# SERVICE BULLETIN

## “-B” Chop-Check Pump Changes

LOWER PUMP ENDS AFFECTED: 66243-X, 66266-X

RELEASED: 2-5-99  
REVISED: 1-10-12  
REV: 01  
BULLETIN: #2-99  
FORM: 4318-2

**LOWER PUMP END SEAT SEAL REDESIGN** - In order to update “Old Style” lower pump ends all four new parts are required.

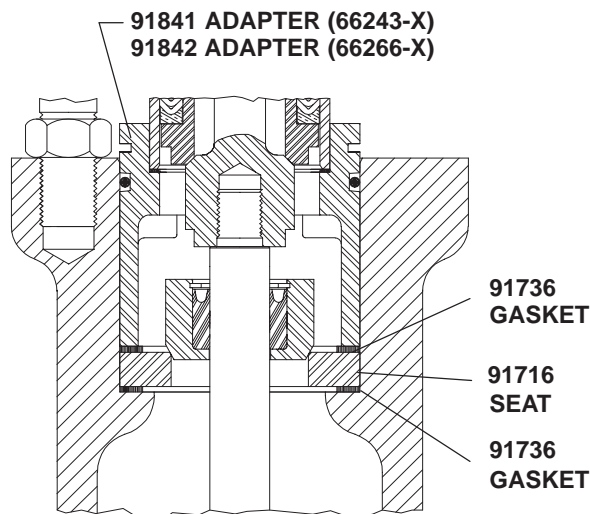
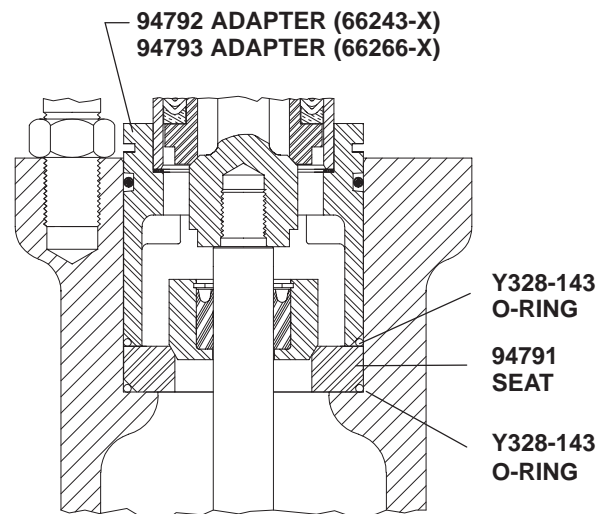
- 1) 91716 (2) Gaskets are replaced by Y328-143 (2) Teflon “O” rings.
- 2) 94791 Seat features the new design.
- 3) 91841 Adapter replaced by 94792 on models 66243-X.  
91842 Adapter replaced by 94793 on models 66266-X.

**Service Kit Note:** New 637071-X-B and 637074-X-B Kits also include (2) replacement 91736 copper gaskets which are required to service old style 66266-X43 and 66243-X43 models.
